NP-11-0014
May 13, 2011

Subject: Exelon Nuclear Texas Holdings, LLC
Victoria County Station Early Site Permit Application
Response to Request for Additional Information Letter No. 06
NRC Docket No. 52-042

RAI 02.04.04-2:**Question:**

Figure 1. Time History of Water Level at the Southwestern Corner of the Security Wall for Manning's n Sensitivity Test (The water level for $n=0.03$ is the same as SSAR Figure 2.4.4-21, and the starting time is arbitrarily selected.)

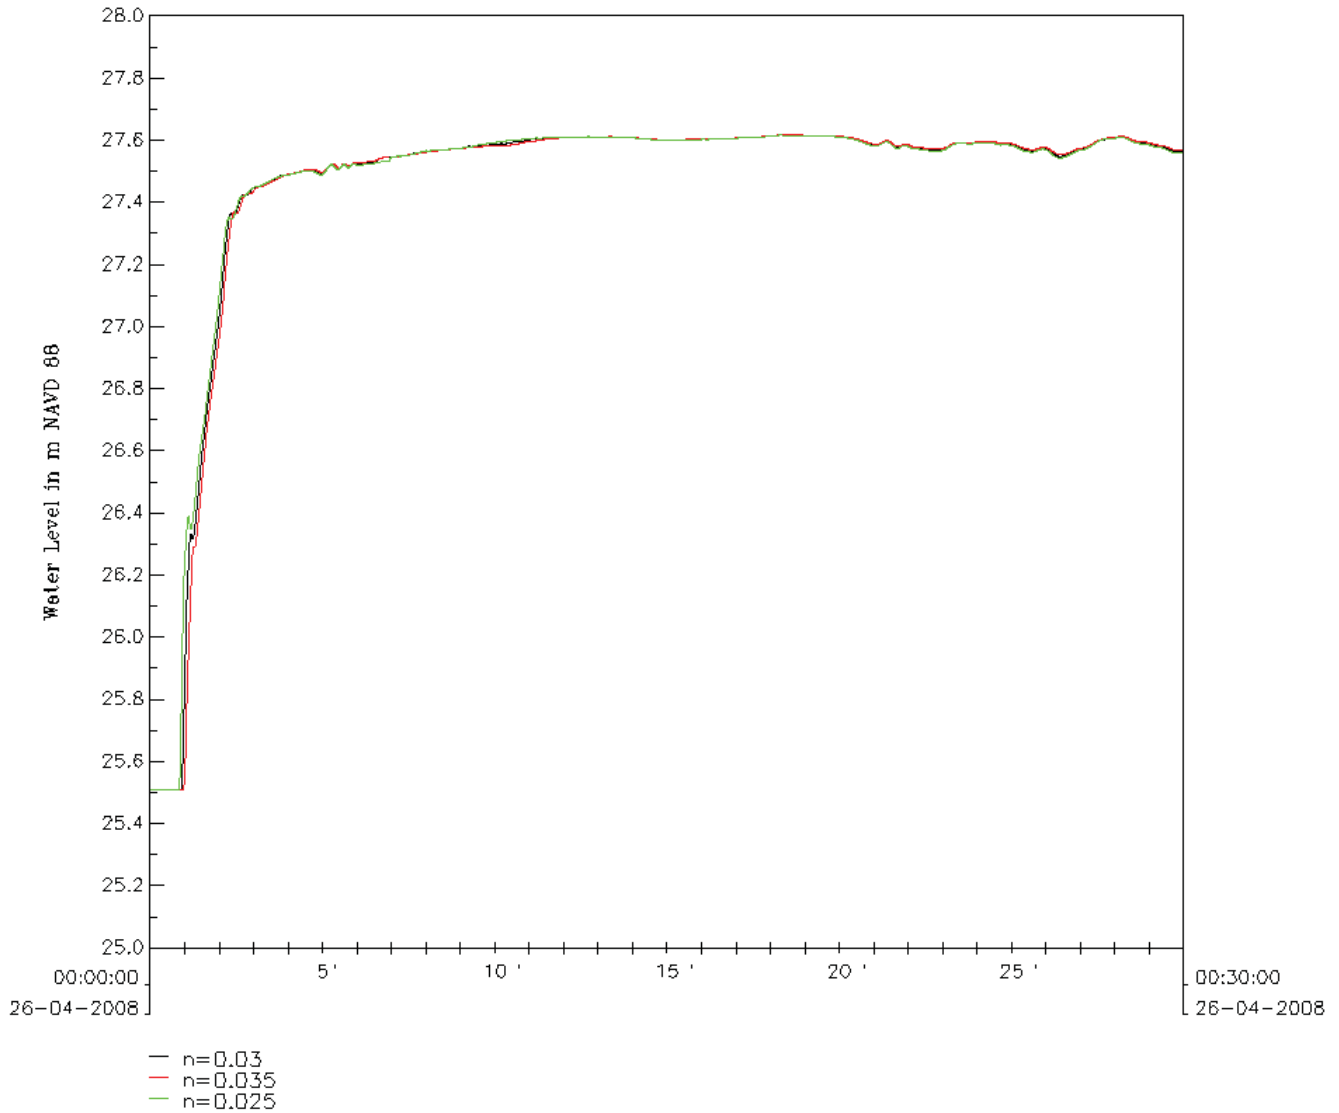
The staff has reviewed the application in accordance with the requirements of “Factors to be considered when evaluating sites” 10 CFR 100.20(c), and “Contents of application: technical information in the final safety analysis report” 10 CFR 52.79(a). The application does not provide detailed information discussing the cooling basin pool elevation selected for analysis and does not provide the background on the selection of the Manning’s n . Please provide additional information showing the selection of the cooling basin initial water surface elevation and the selection of Manning’s n in the vicinity of the breach, where applicable, considering that there are more conservative assumptions available.

With the normal maximum operating water level of the CB at 91.5 feet (27.9 meters) NAVD 88, the maximum water level in the CB from routing the one-half PMP; i.e., the initial CB water level, is 93.9 feet (28.62 meters). This value is slightly higher than the direct summation of the normal maximum operating water level of the CB and the one-half PMP falling on the CB; i.e., 93.8 feet (28.59 meters). The difference is due to the runoff contribution from the embankments and dikes to the CB water body.

Figure A-1

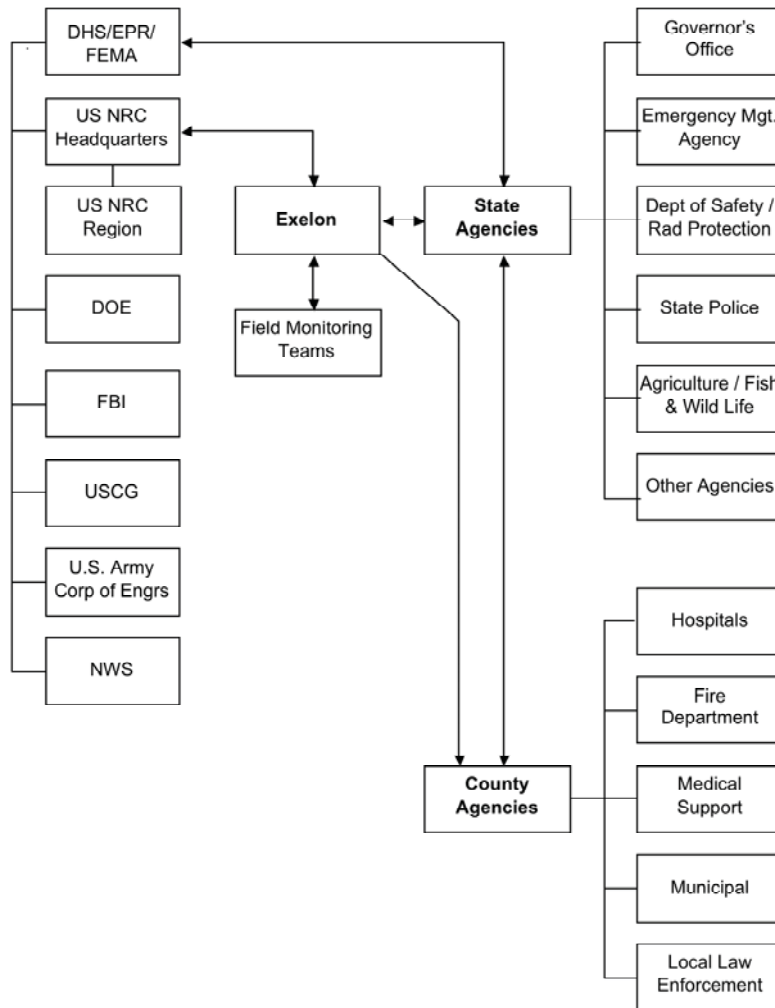
- RAI A-7. Include the Department of Homeland Security (DHS) in Figure A-2 of the Exelon Nuclear Standardized Radiological Emergency Plan, "Agency Response Organization Interrelationships" or justify why this is not necessary.
- RAI A-8. Section A.3 of the Exelon Nuclear Standardized Radiological Emergency Plan, "Agreements in Planning Effort," explains that written agreements have been developed that establish the concept of operations between the applicant and other support organizations having an emergency response role. Provide copies of the Letters of Agreement established with local support agencies in the Emergency Plan or Annex, or describe where these documents are maintained.

RAI A-7 Figure A-1 in the VCS Annex has been revised to replace FEMA with DHS/EPR/FEMA.

Figure 4-1: Victoria County Station PAR Determination Flowchart

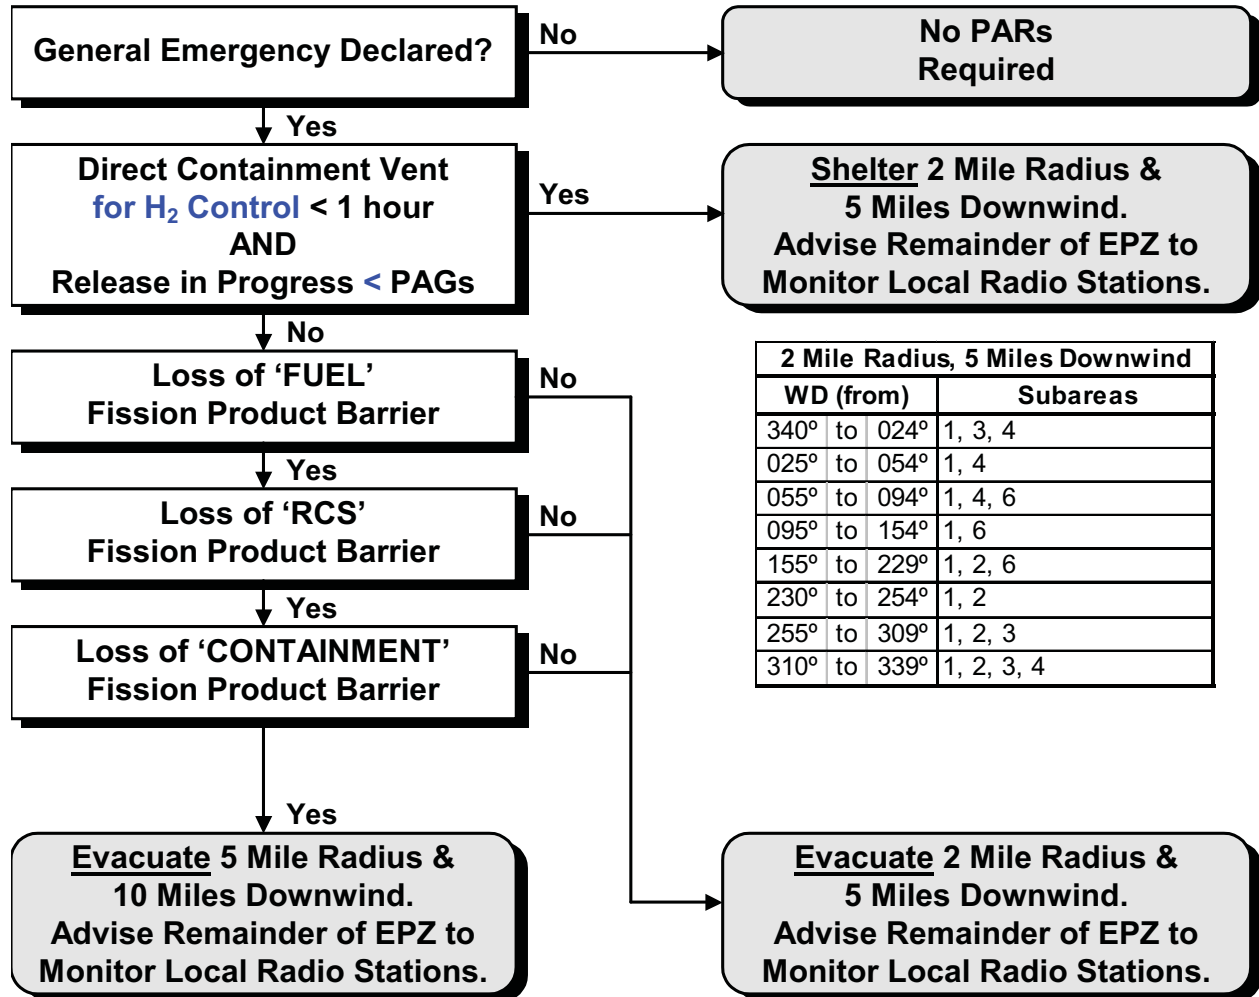
- RAI J-5. Figure 4-1, "Victoria County Station PAR Determination Flowchart," of the Victoria Annex provides the steps considered in making the PAR determination. Explain in the Annex how the Evacuation Time Estimate is used in conjunction with PARS to develop the evacuation plan or justify why this is not necessary.

RAI J-5: NUREG-0654, Supplement 3 provides guidance on the issuing of Protective Action Recommendations (PARs) for the general public. Unless determined by Exelon during a declared General Emergency that the release of radioactive material is a "puff release" the ETE will not be considered when making protective action recommendations. The Plant operators may not have information regarding the environmental concerns regarding the off-site areas surrounding the site. The county or state officials will take into consideration the ETE for the current environmental conditions and make a decision to utilize the VCS PARs or to modify them based on additional information that they have concerning the evacuation routes.
